From: [Zach Robbins](#)
To: [Yu, Olivia, EMNRD](#)
Cc: "Jacob Mickle"; stan.mickle@rxsoil.solutions; [Billings, Bradford, EMNRD](#)
Subject: RE: Ruth Co. SWD - 1RP-4572-0 - RXSoil
Date: Thursday, October 19, 2017 11:20:03 AM
Attachments: Ruth Co Closure Report Ammendment - 10-19-17.pdf

From: Yu, Olivia, EMNRD [mailto:Olivia.Yu@state.nm.us]
Sent: Monday, October 16, 2017 2:43 PM
To: Zach Robbins <zach.robbs@rxsoil.solutions>
Cc: Jacob Mickle <jacob.mickle@rxsoil.solutions>; stan.mickle@rxsoil.solutions; Billings, Bradford, EMNRD <Bradford.Billings@state.nm.us>
Subject: RE: Ruth Co. SWD - 1RP-4572-0 - RXSoil

Please address these concerns regarding the closure report for 1RP-4572.

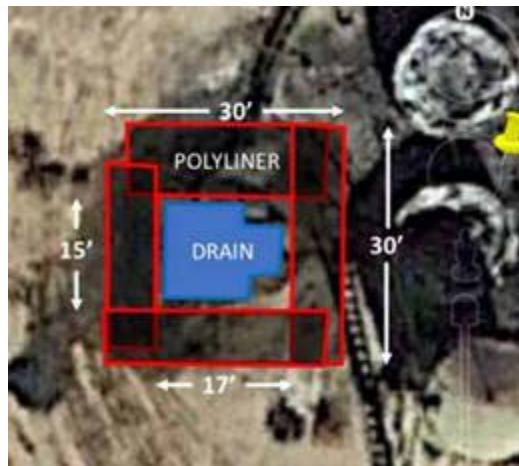
1. On the scaled map, label which areas are identified as 1, 2, and 3 and demarcate confirmation sample locations.

Here is an overview with the areas labeled.
